Landscape Response
to application by Taylor Wimpey
DC/21/02671
for
Sproughton Parish Council
July 2021

Lucy Batchelor-Wylam
Landscape architecture LucyBW@outlook.com

5. This report is submitted to Sproughton Parish Council. Its purpose is to inform their response to an outline planning application (DC/21/02671) for circa. 750 dwellings on 53ha of farmland to the northeast side of the parish which is 'live' at the time of writing. It will also inform any opportunity to comment on the allocation of land parcel LA013 in the emerging Joint Local Plan (JLP).
6. The aim of the exercise was to consider likely impacts of the proposals on:
 - the character of the landscape, and particular to the aspects which contribute most strongly,
 - the function of the landscape, and to its role as setting to the edge of Ipswich.
 - the landscape as setting and backdrop to heritage assets and the effectiveness of mitigation offered;

Figure 1: Understanding the land parcel surrounding Chantry Vale

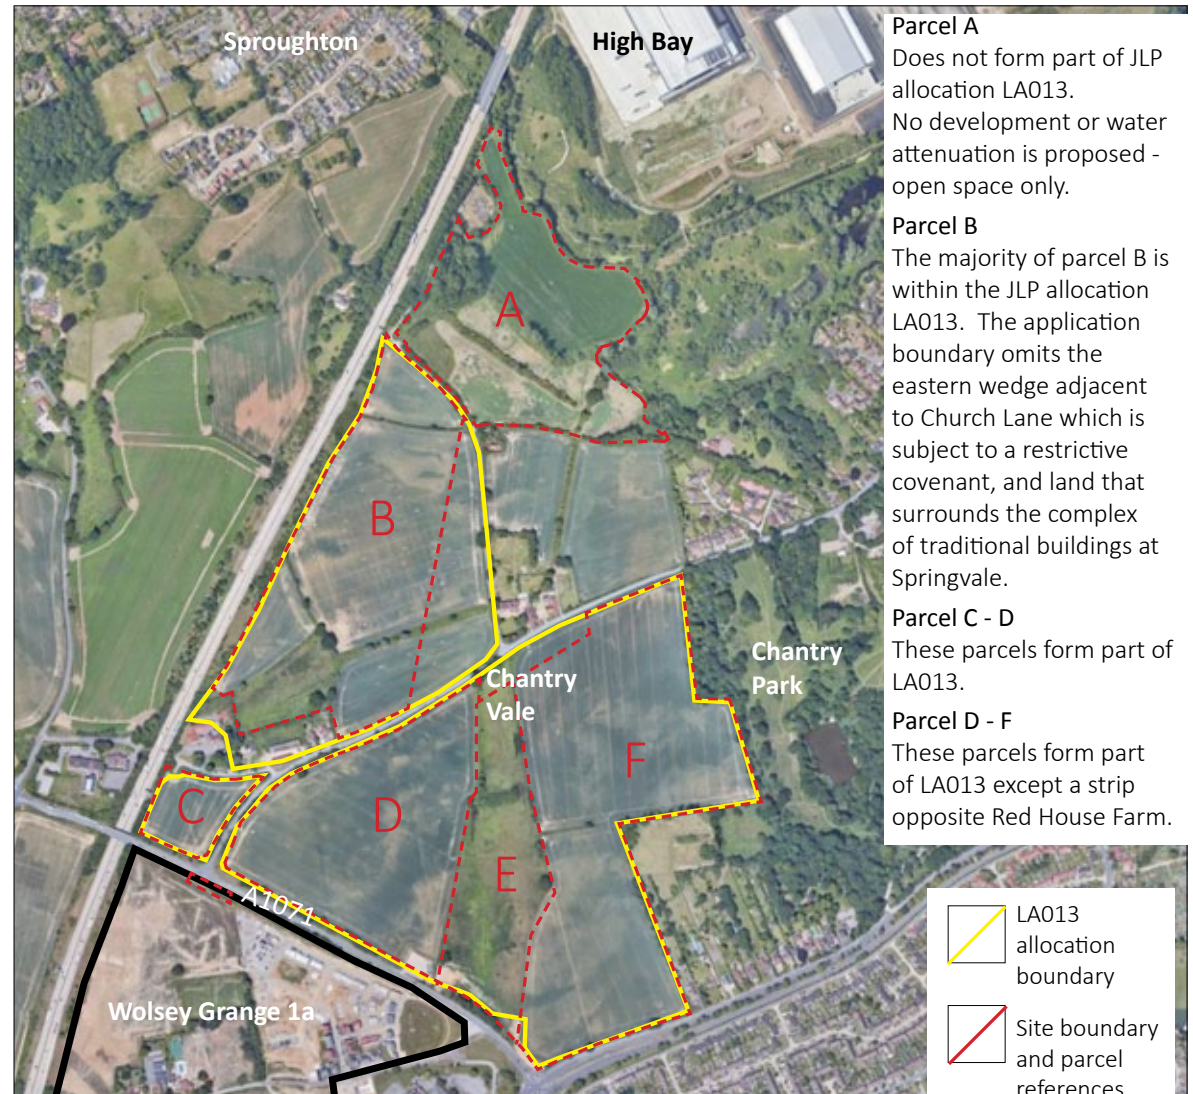
Parcel A
Does not form part of JLP allocation LA013. No development or water attenuation is proposed - open space only.

Parcel B
The majority of parcel B is within the JLP allocation LA013. The application boundary omits the eastern wedge adjacent to Church Lane which is subject to a restrictive covenant, and land that surrounds the complex of traditional buildings at Springvale.

(Photo location Hb on page 6)

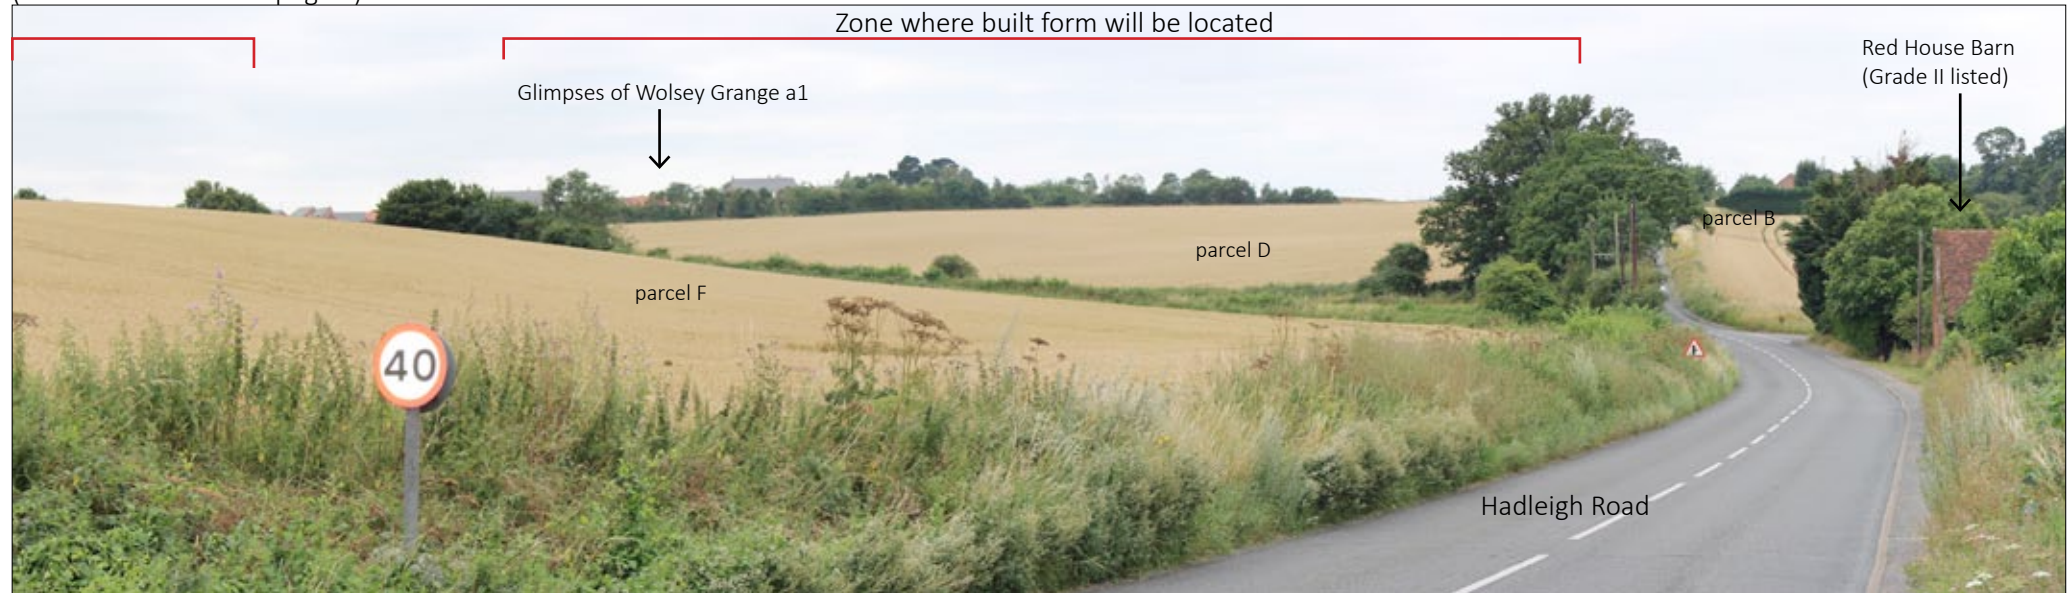
skyline. The character of this view, and the setting of the Red House and its barn will be permanently adversely affected.

6. The only mitigation currently on offer is a hedge with scattered trees to the front (east) of development in parcel B. This will not provide any meaningful screening. The proximity of the proposed hedgeline to the foundations of new dwellings indicates that the trees proposed are unlikely to be parkland scale or skyline impact trees unless the additional engineering costs are factored in from the start. In any case mitigation is NOT likely to prove feasible given the heights of the built form proposed and because;

7. The detached position of the development will have a very poor relationship to the current settlement edge and will prove visually confusing. The function of the landscape as setting to the edge of Ipswich and as a rural gap will be substantially eroded.
8. A further issue is the imposed straight edge to development in parcel B. This will be

at odds with the soft organic patterns in the landscape as created by the hydrology/topography and ancient enclosure field patterns north of Hadleigh Road. The ruler-straight line defining the restricted covenant land west of Church Lane cuts through the softer patterns leaving the ‘left over’ areas evident.

9. There is scope to integrate any development edges in a more creative way. A more deeply vegetated and sympathetic shaped edge that shows some relationship to existing patterns would be an improvement and help prevent a feeling of ‘left over’ land.
